**Code Technology Committee
2010 Final Action Agenda
CLIMBABLE GUARDS**

The following are code changes and public comments to be considered at the 2010 Dallas Final Action Hearings that are related to the CTC Area of Study noted above.

E100-09/10, Part I
1002.1, 1013.2 (IFC [B] 1002.1, 1013.2)

Elevation view of individual seat configuration, IBC Section 1013.2, Item 2:

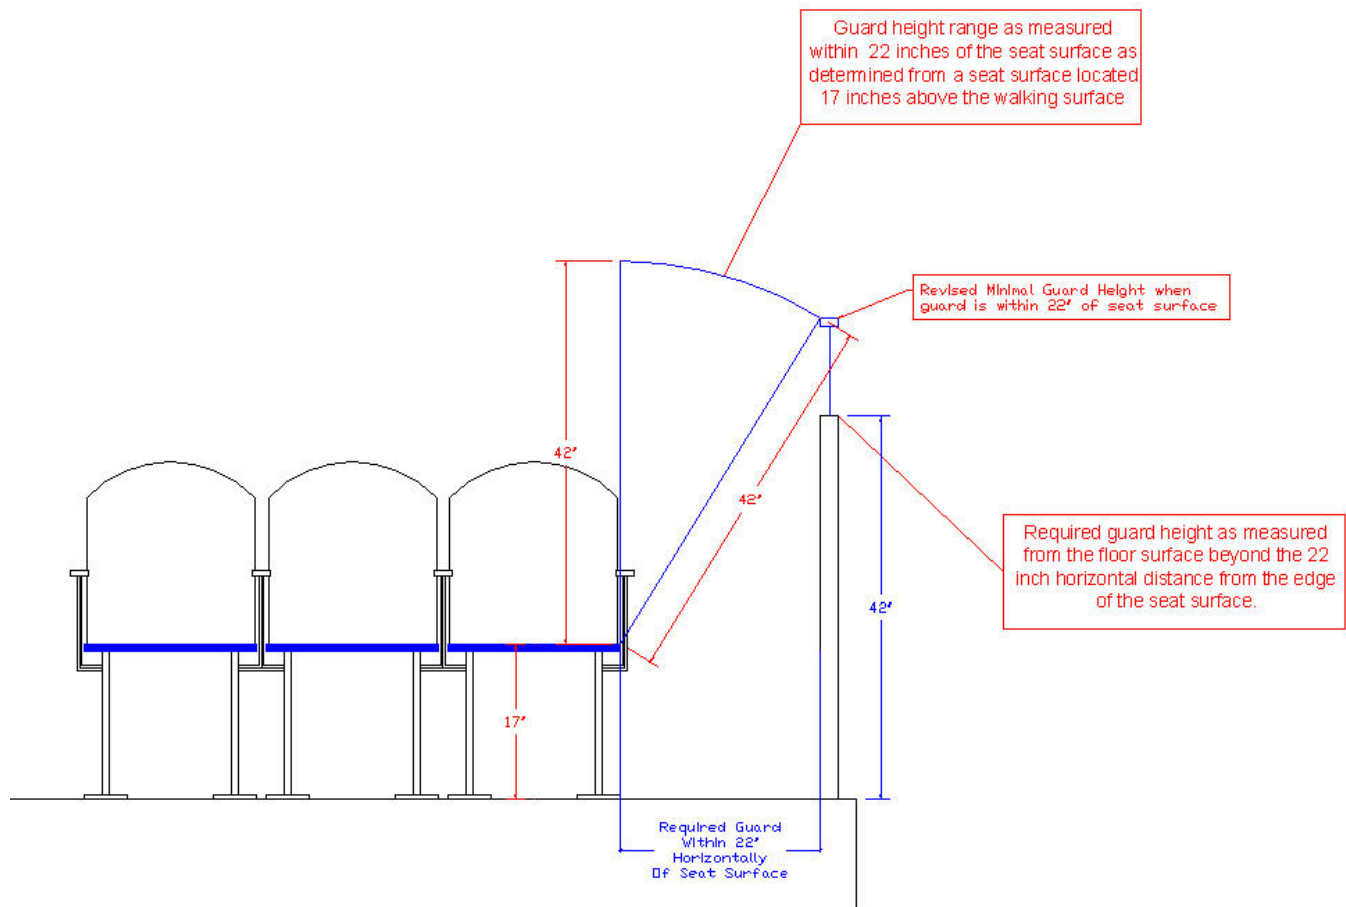
Commenter's Reason: As noted by the code committee, there was some confusion as to how to make the measurements as well as the need to coordinate these changes with experts in assembly seating. In response, the CTC has partnered with the proponent of code change E147 who is an expert in assembly seating. Further, the CTC provides the following illustrations which show the relationship between the height of the guard and its proximity to the seating surface. This comment should be considered with E147.

If the code change is approved, the illustrations is intended to be added to the IBC Commentaries. The following illustrates the applications of the code requirements:

1013.2 (IFC [B] 1013.2) Height. Required guards shall not be less than 42 inches (1067 mm) high, measured vertically as follows:

1. From the adjacent walking surfaces;
2. From a seat surface of adjacent fixed seating, with or without arm or back rests, within 22 inches measured horizontally of a required guard, the guard height shall provide a minimum 42 inches measured diagonally between the top of the guard and the nearest edge of the seat surface;
3. On stairs, from the line connecting the leading edges of the tread nosings; and
4. On ramps, from the ramp surface at the guard.

Elevation view of bench seat configuration – IRC 312.2, Item 2:

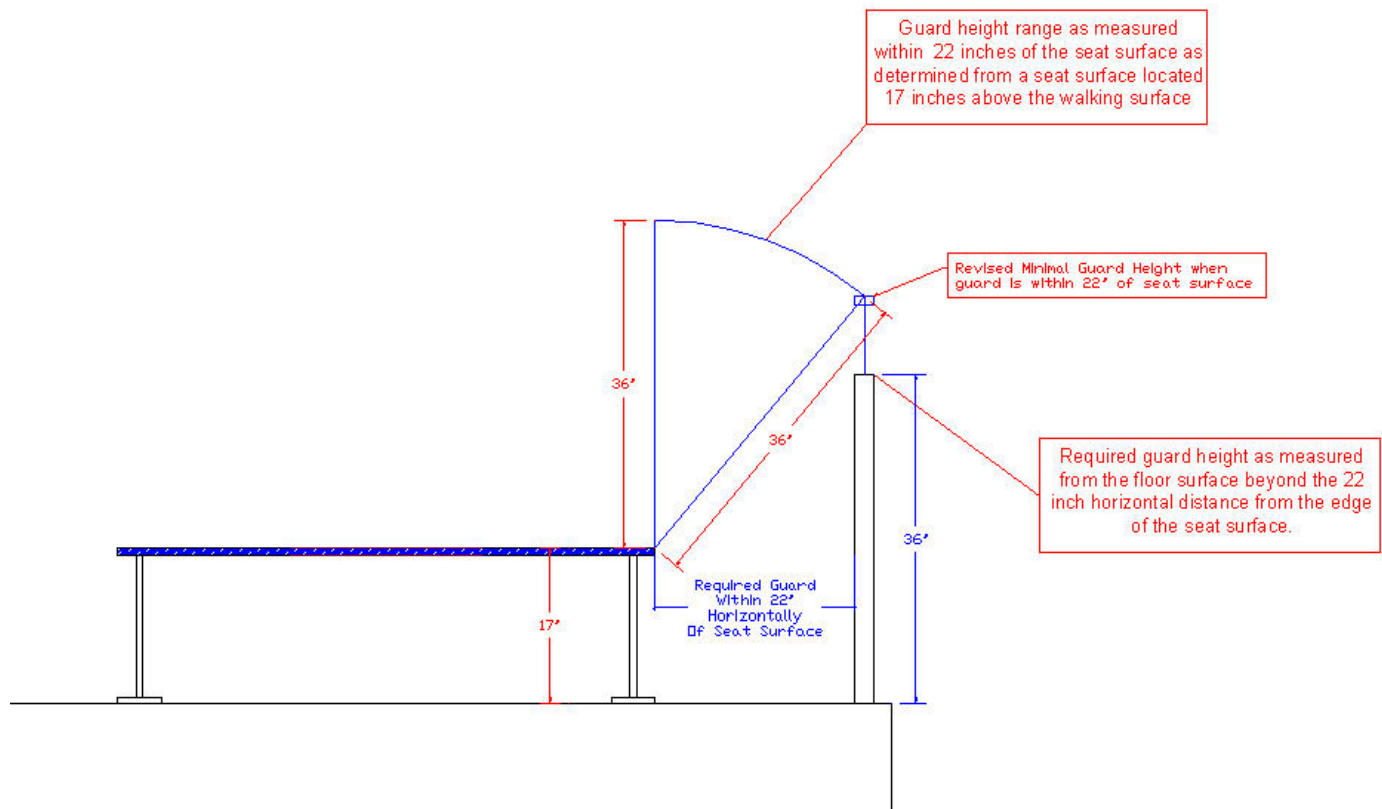
Commenter's Reason: As noted by the code committee, there was some confusion as to how to make the measurements as well as the need to coordinate these changes with experts in assembly seating for the IBC requirements. If the code change is approved, the illustrations is intended to be added to the IRC Commentaries. The following illustrates the applications of the code requirements:

R312.2 Height. Required guards at open-sided walking surfaces, including stairs, porches, balconies or landings, shall be not less than 36 inches high measured vertically as follows:

2. From a seat surface of adjacent fixed seating, with or without arm or back rests, within 22 inches measured horizontally of the required guard, the guard height shall provide a minimum 36 inches measured diagonally between the top of the guard and the nearest edge of the seat surface;
3. On stairs, from the line connecting the leading edges of the tread nosings; and
4. On ramps, from the ramp surface at the guard.

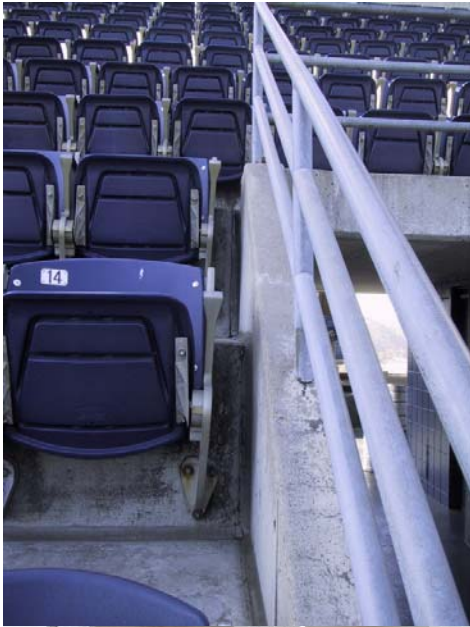
Following are two photographs of self-rising chairs and one of bench seats. The fixed bench seating could serve as a walking surface, however the self-rising chairs are not easily used as a walking surface. 2007 ICC 300 measures vertically above the leading edge of the tread, adjacent walking surface or adjacent bench seat. This proposal maintains how the height of the guard is measured by 1013.2 with the exception of replacing the term "fixed seat" with the term "bench seat" to coordinate with ICC 300 and to enhance clarity that guard height needs to be measured vertically above such seats. Also, the term "bench seat" rather than "seatboard" is commonly used for this type of seating in assembly seating project specifications. An exception was added for self-rising chairs since these seats are not easily used as a walking surface and there is no well defined way to measure these chairs.

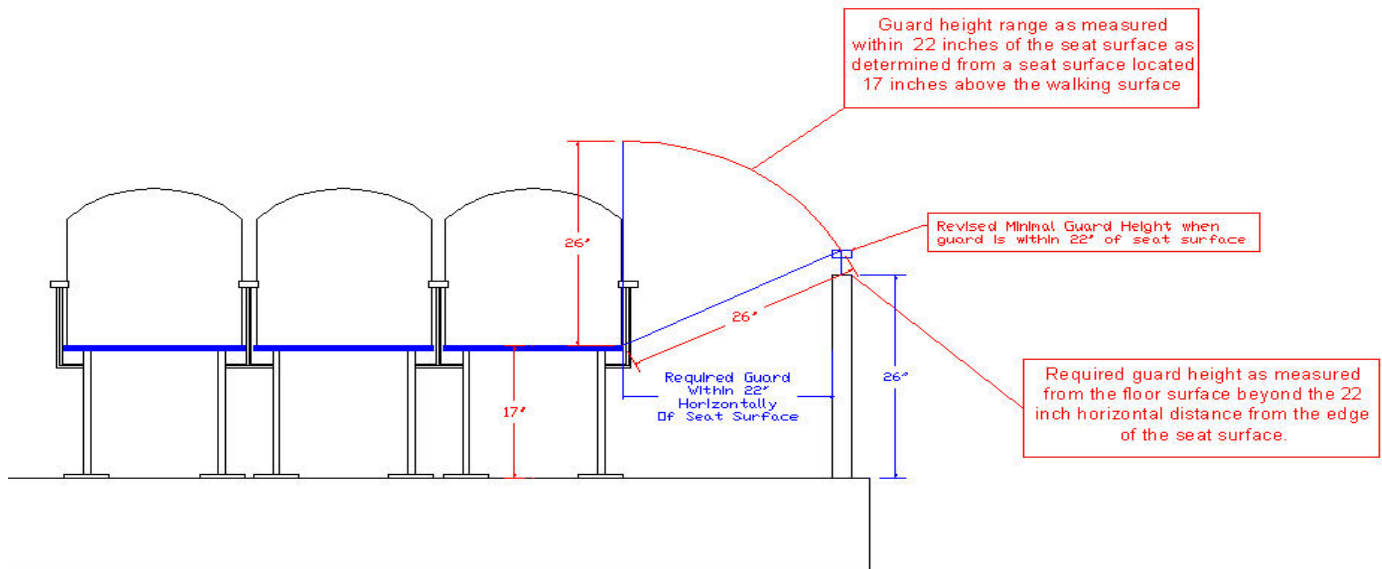
Commenter's Reason: As noted by the code committee, there was a need to coordinate CTC's proposed E100 and Ed Roether's E147 who is an expert in assembly seating design. This comment is in recognition of that need.

The public comment to this code change, along with the comment to E100, will bring clarity to the required height of guards in assembly seating. Confusion resulted when the term "seatboard" was replaced with "fixed seating" in Section 1013.2. It is recognized that E100 provides the needed clarity to how the height of guards is measured where the line of sight is not a consideration, but line of sight in assembly seating is critical. The revised exception to Section 1028.14.2 addresses line of sight issues. This exception does not alter the height of guards immediately beside or behind seating or other conditions as established in Section 1013.2. The minimum height of 26 inches would be measured in accordance with 1013.2 where the guard would otherwise interfere with the line of sight and the minimum height of 42 inches would be measured in accordance with 1013.2 where there is not interference with line of sight. This comment and that of E100 should be heard together. Please see the illustrations published with the public comment to E100-09/10.

The following illustrate how guards would be measured in assembly seating.

1028.14.2 (IFC [B] 1028.14.2) Sightline-constrained guard heights. Unless subject to the requirements of Section 1028.14.3, a fascia or railing system in accordance with the *guard* requirements of Section 1013 and having a minimum height of 26 inches (660 mm) ~~measured vertically above the adjacent walking surfaces, adjacent bench seat or the line connecting the leading edges of the treads~~ shall be provided where the floor or footboard elevation is more than 30 inches (762 mm) above the floor or grade below and the fascia or railing would otherwise interfere with the sightlines of immediately adjacent seating. At *bleachers*, a *guard* must be provided where required by ICC 300.

Exception: ~~The height of the guard shall not be required to be measured vertically above an adjacent automatic or self-rising chair.~~ The height of the guard in front of seating shall be measured from the adjacent walking surface.

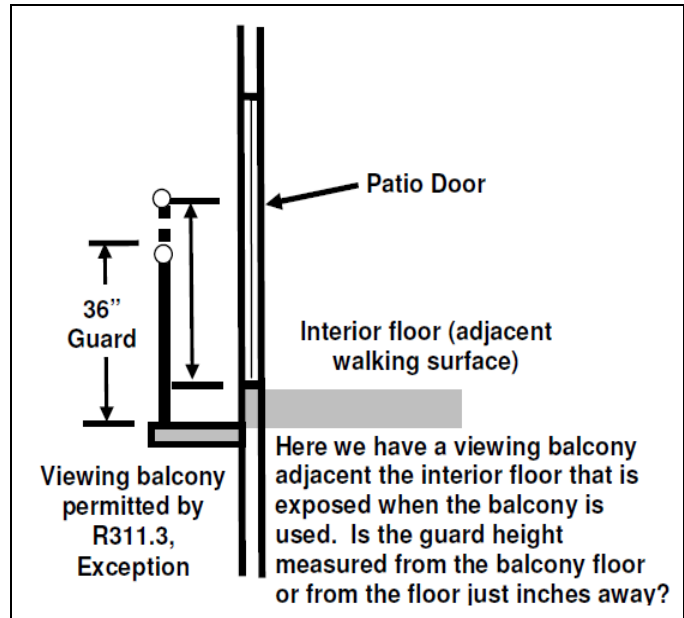
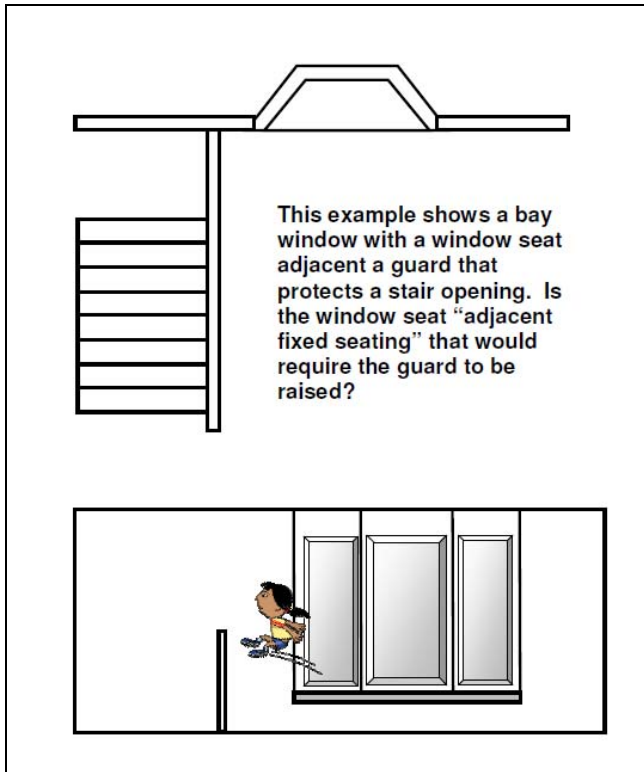
The current language also creates confusion regarding the use of insect screening. The 2006 IRC language was patterned after that found in the IBC and read: "Porches and decks which are enclosed with insect screening shall be equipped with guards where the walking surface is located more than 30 inches (762 mm) above the floor or grade below." It was clear that the intent was to prohibit screening that was commonly used in screen porches and similar structures from meeting the requirements of a guard.

This picture illustrates two issues that arise with the current language on guards. First, we have a walking surface that is more than 30 inches above a point within 36 inches of the open side of the walking surface. Therefore a guard 36 inches high is required. Then we have adjacent fixed seating in the form of the seating around the edge of the hot tub. The seating is 42 inches above the walking surface. Therefore the total height of the guard at this location will be 78 inches. The IRC requires that the guard be able to resist a "single concentrated load (of 200 pounds) applied in any direction along the top." This will require some very substantial mounting hardware to attach the guard to the patio to resist such forces.

Each of these photos illustrates a possible application of a guard next to adjacent fixed seating. In all of the pictures one could interpret the code to require that the guard be 36 inches higher than the adjacent fixed seating. In the photo to the lower left, the edge of the hot tub is approximately 6 inches above the floor of the deck. Therefore the railing should be raised for that portion of the railing that is considered "adjacent the fixed seating.

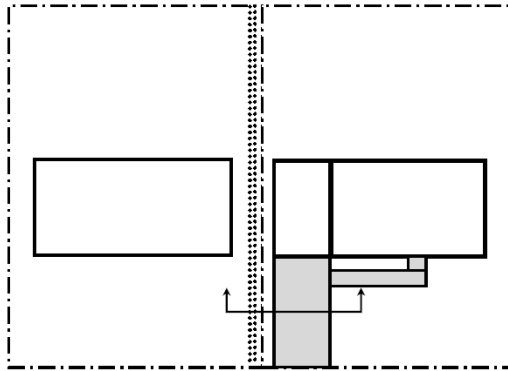
If the retaining wall is more than 30 inches high, must a guard be placed along the driveway which creates an open sided walking surface if the edge of the driveway is less than 36 inches from the wall? The retaining wall is on the neighbor's property. Who must install the guard, the owner creating the hazard or the owner creating the walking surface? Could the owner of the driveway place a guard along the driveway or must it be installed at the lot line?
